SUBJECT: AMENDMENT NOS. 168 AND 172 TO FACILITY OPERATING LICENSE
NOS. DPR-24 AND DPR-27, POINT BEACH NUCLEAR PLANT,
UNITS 1 AND 2 (TACS M89550 AND M89551)

ATTACHMENT TO LICENSE AMENDMENT NOS. 168 AND 172
TO FACILITY OPERATING LICENSE NOS. DPR-24 AND DPR-27
DOCKET NOS. 50-266 AND 50-301

SAFETY EVALUATION BY THE OFFICE OF NUCLEAR REACTOR REGULATION

POINT BEACH NUCLEAR PLANT, UNIT NOS. 1 AND 2

Figure 15.3.1-1/PBNP Units 1 & 2
Heatup Limitations Applicable to
23.6 Effective Full Power Years
(Approximately January 2001)

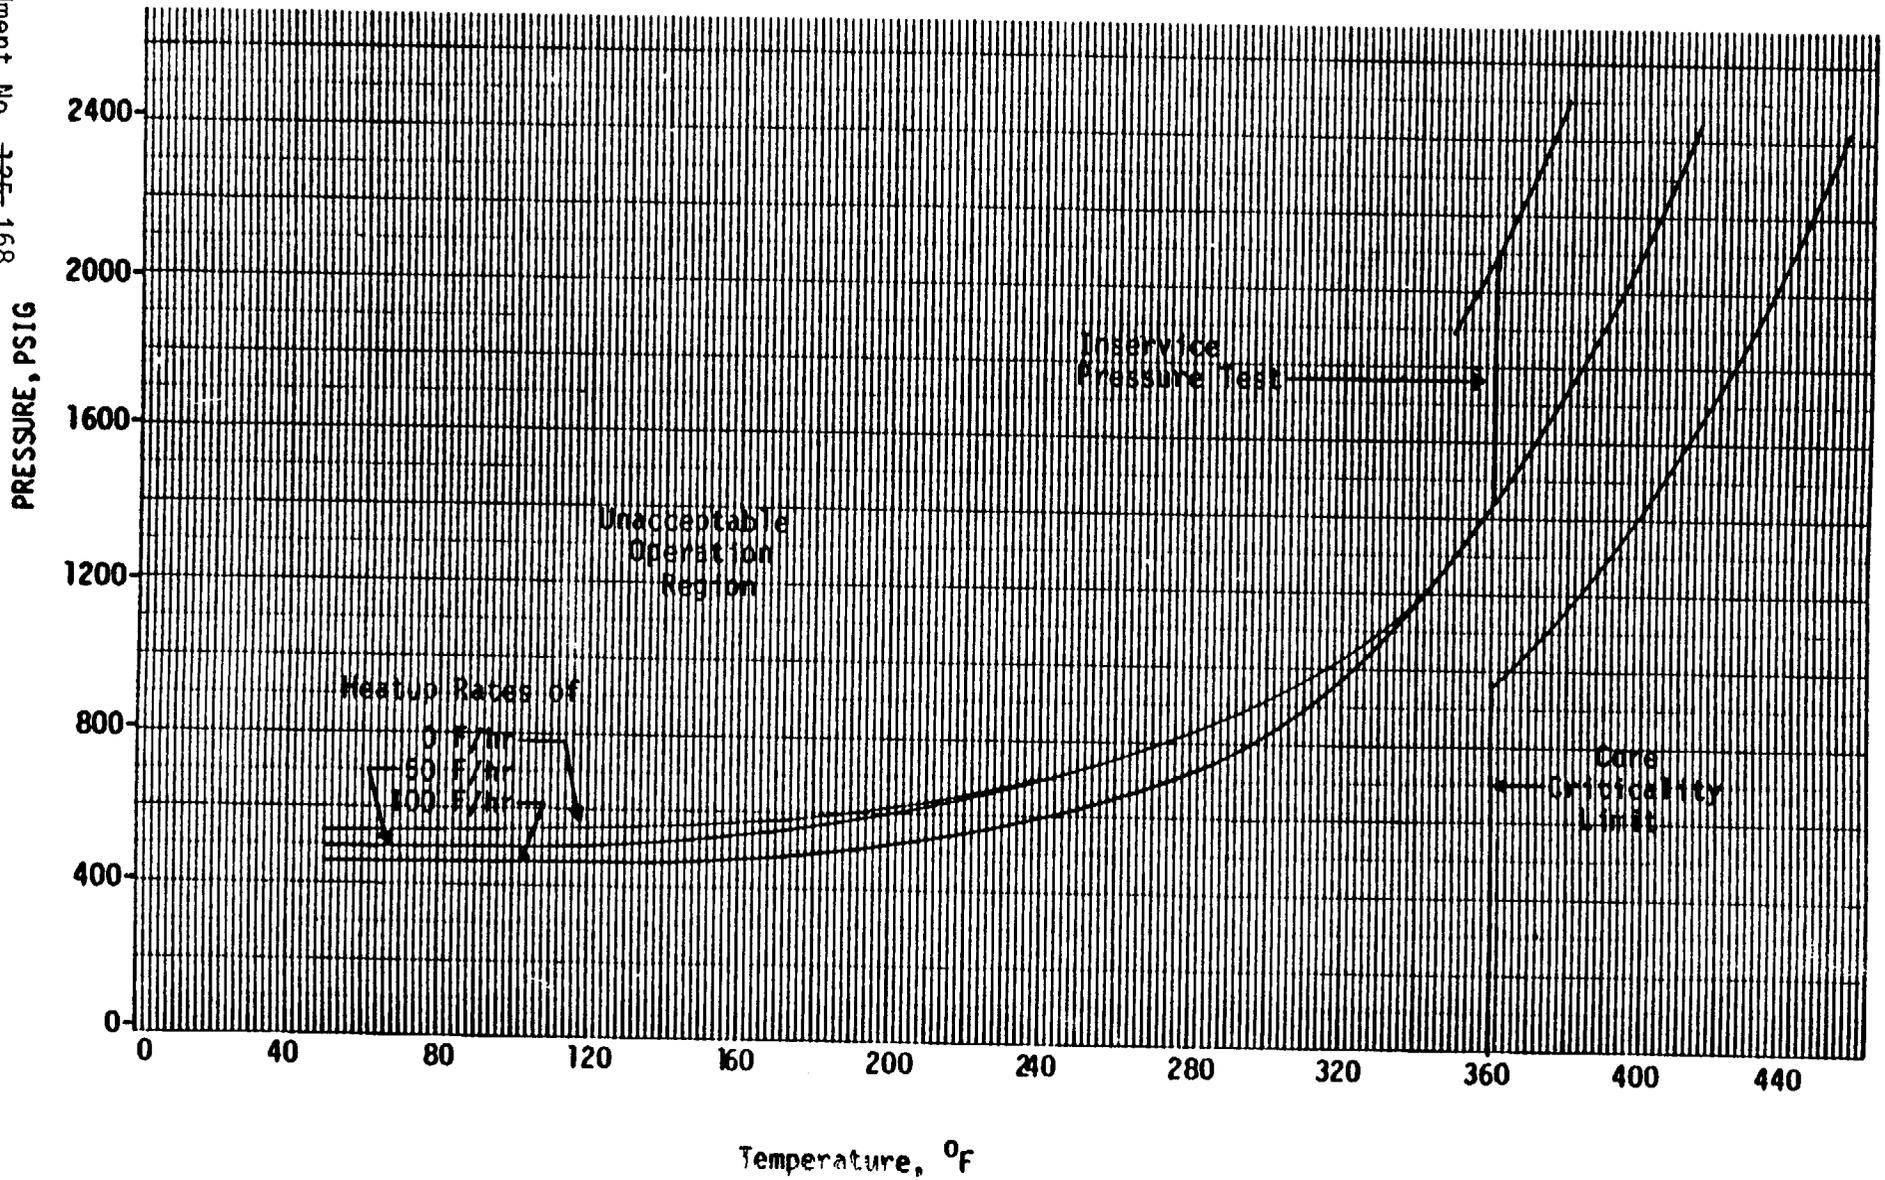
The length of time and date of applicability for Figures 15.3.1-1 and 15.3.1-2 are being changed to 23.6 EFPY and January 2001. These changes are consistent with the licensee's submittal and with the staff's evaluation, and are therefore acceptable. The bases for TS 15.3.1 are also being modified. The
